# CITY PLAN COMMISSION STAFF REPORT

**Project Name**  
Summit View Farms

**Docket #6**

SUMMIT VIEW FARMS  
DEVELOPMENT PLAN AND PRELIMINARY PLAT

SUMMIT VIEW FARMS  
 PRELIMINARY PLAT  
 TYPICAL ROAD SECTIONS  
 KANSAS CITY, JACKSON COUNTY, MISSOURI

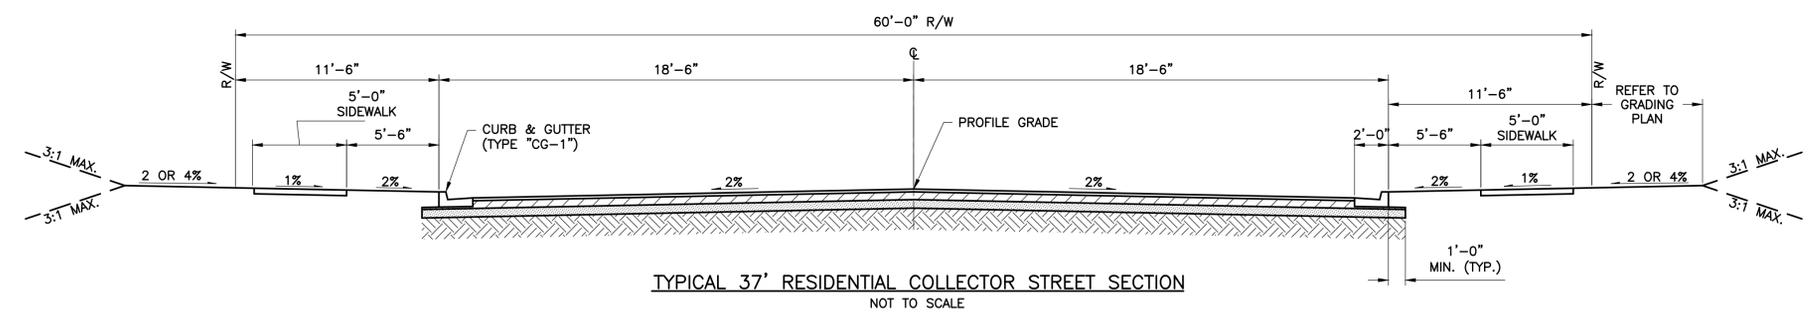
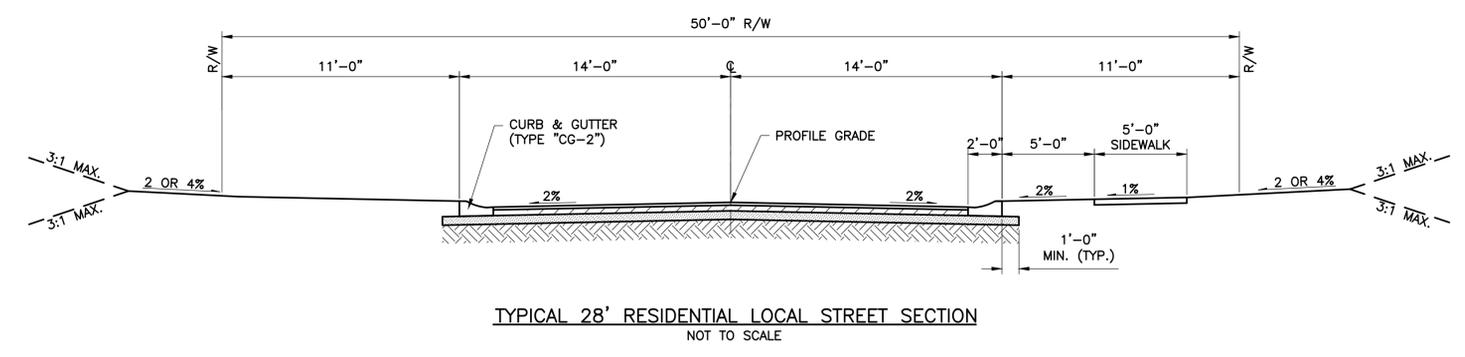
The applicant is requesting a waiver to this requirement to only install sidewalks on one side of the local public streets. Staff is not supportive of this request as it does not meet the public work's standard and will leave the burden of installing the remaining sidewalks on the city down the road. The applicant also has not provided staff with any rationale as required by Section 88-405-25-C-1 below:

The proposed development is asking for a waiver to only provide sidewalks on one side of the local public streets which does not meet the public works standards. Staff is not supportive of this request. See analysis. OA

5. a. Sidewalks on both sides of all local public streets within the development.  
b. A preliminary landscape buffer plan sheet depicting the treatment of the 30 foot POS along Horridge Road as it relates to the existing water main transmission line and for Lots 294-299 and Lot 286. This should include a cross section to ensure that the rear yards are adequately buffered from the public rights of way.
